**MATRIX DEVELOPMENT, LLC**

RE: Chazen 12-17-2021 HNGC/Matrix Development – Solar Project - Engineering Review

In response to Chazen Companies recent engineering review dated 12-17-2021 the following responses have been prepared for consideration.

Figure (1) – Prickly Pear Hill Rd

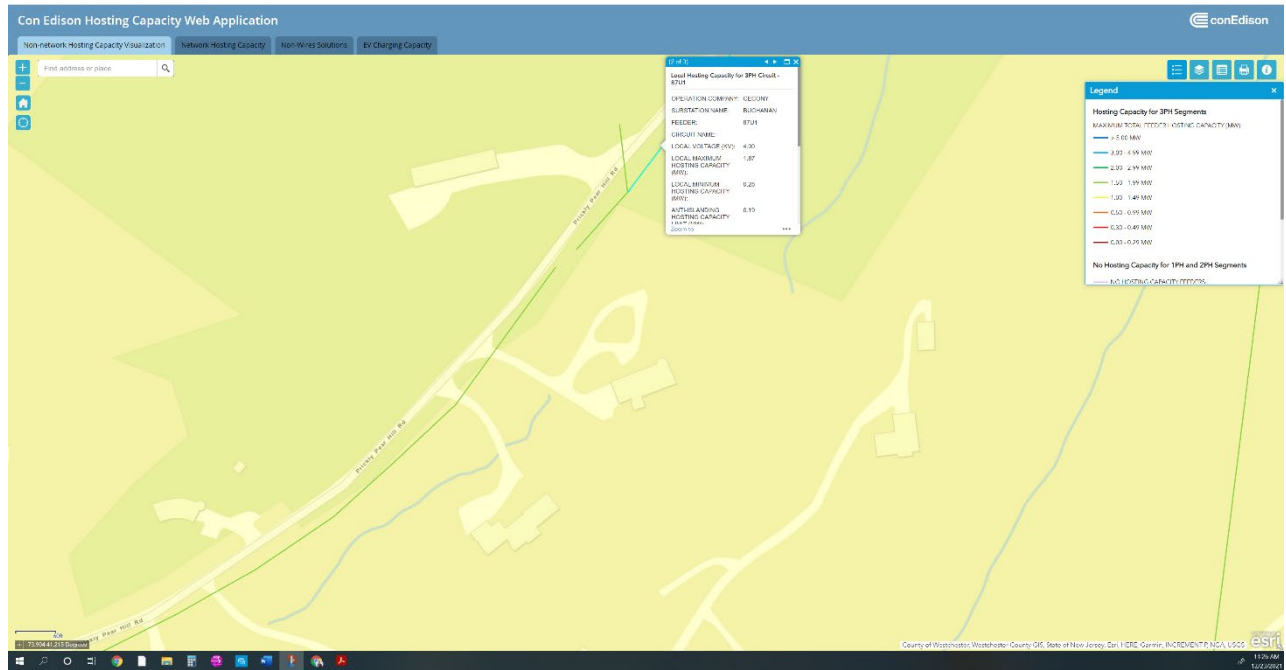
4. The applicant provided a detailed explanation of the reason for the location of the array, but can Matrix please identify if there are other potential points of interconnection (POI) around the HNGC property? And is it the role of the developer to dictate the POI location, or is that at the sole discretion of the utility company?

**Matrix: No alternative electrical interconnection locations supplied by Con Edison exist on or near the golf course other than Prickly Pear Hill Rd service located at approximately 16 Prickly Pear Hill Rd. Figures 1, 2, and 3, below come directly from the Con Edison Hosting Capacity Map which identify approximate location of available utility circuits and the respective electrical capacity of each line. Neither Arrowcrest Drive, nor Finney Farm Rd circuits have available hosting capacity for a solar system of any size as shown in the attached maps. Arrowcrest and Finney maps specifically indicate “No Hosting Capacity”. It’s the role of the developer to propose the interconnection point based on available hosting capacity information. See also, for additional information, Matrix response letter submitted on December 23, 2021, Alternative Solar Site Evaluation – Old Driving Range.**
